Ref: 117019

11th Feb 2021

Re: S92 Request for Ruakaka Services Station (LUC2000057)

Figure 1: Downstream cross section & flood flow direction

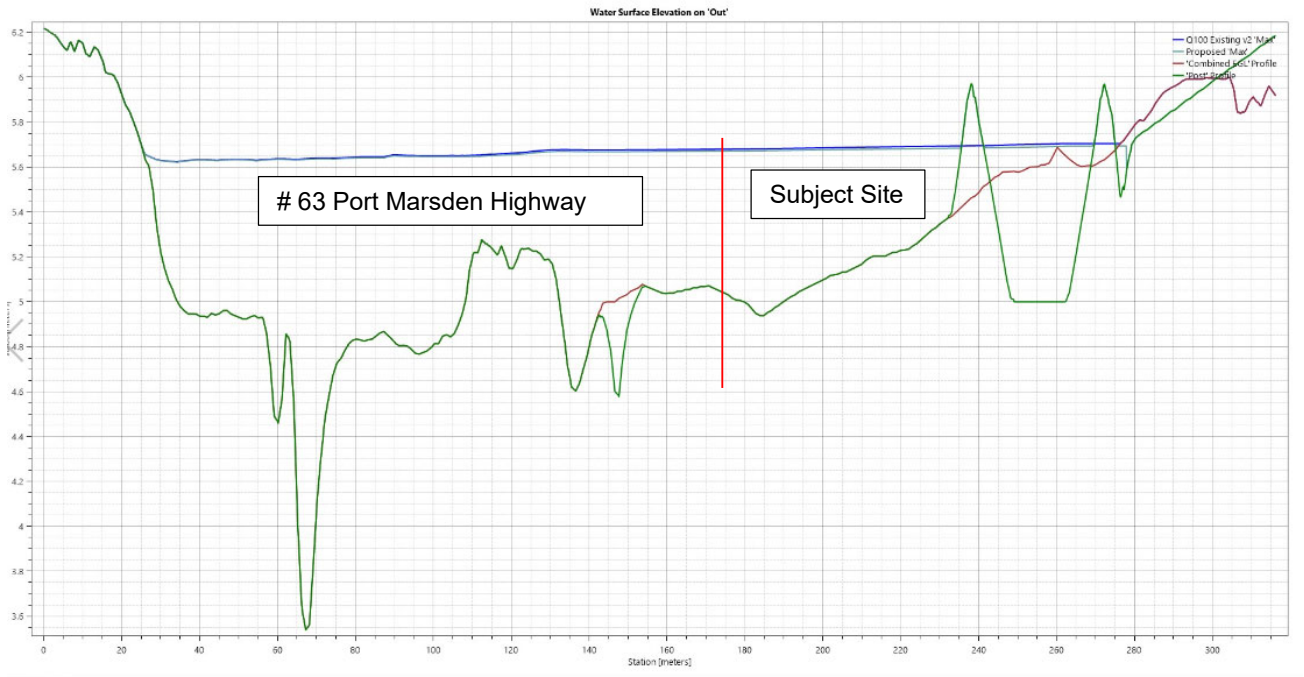
- [2018/19 LiDAR dataset from northland regional Council](#)
- [Site Survey](#)
- [Proposed Surface](#)
- *Please provide indicative profiles at the site showing the pre and post development terrain levels and flood elevations.*

Section through the site at the below location have been provided. Please refer to the attached image below:

Figure 5: Extend of flooding post development

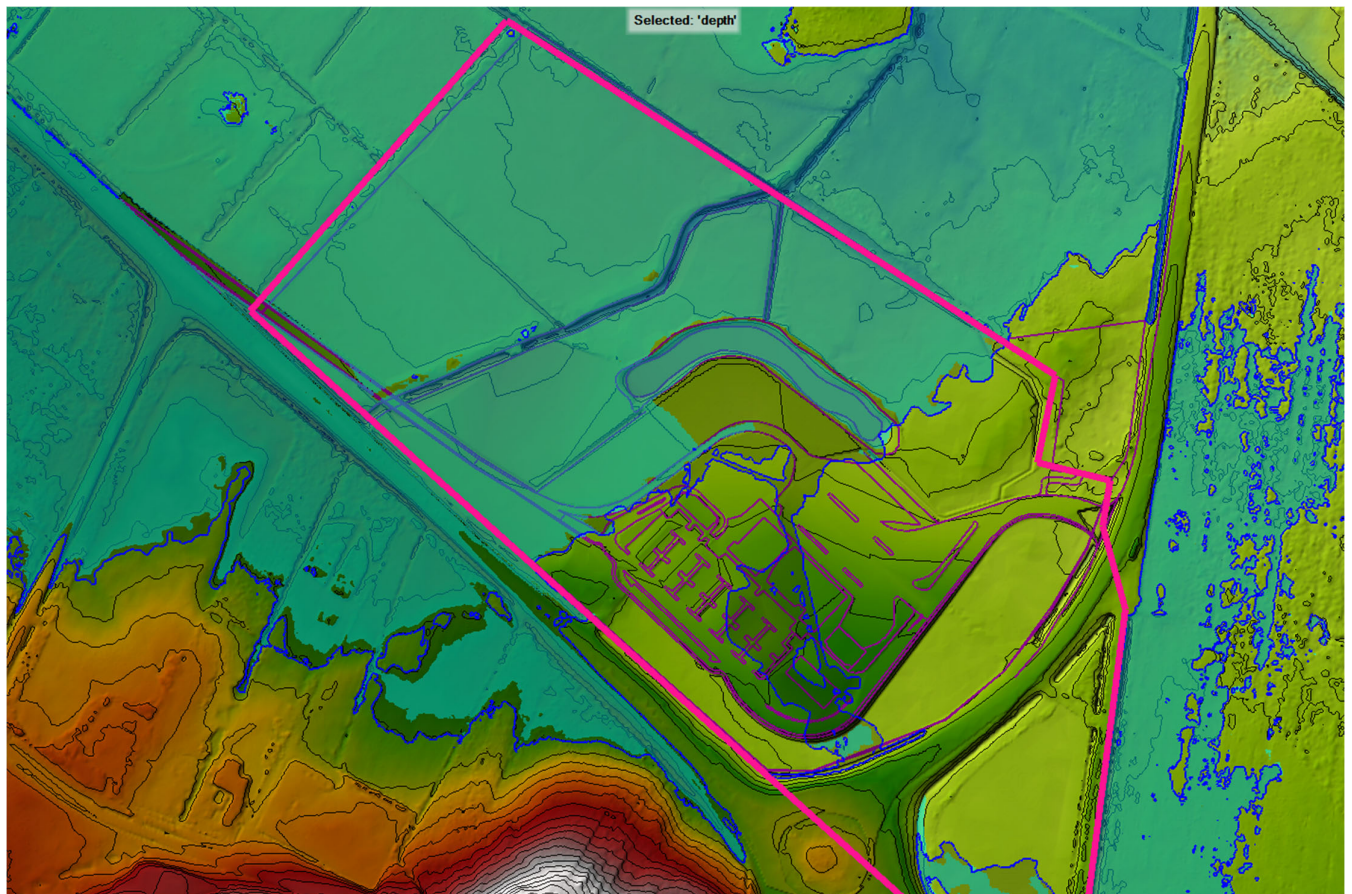
- *Figure 3.9 also indicates that access to the site from SH1 and building areas are within the floodplain post development for the design event, although the proposed site layout is not clear in the scale of the figure.*

- *Could you please provide a site plan only with the pre- and post-development flood extents clearly identified in relation to the site access, buildings and amenities.*

Yes, we anticipate overtopping at the culvert. Please refer to image below for clarification of the building areas and access from SH1 within the flood plain post development

Refer to figure 5 above for clarification of the building areas within the flood plain post development
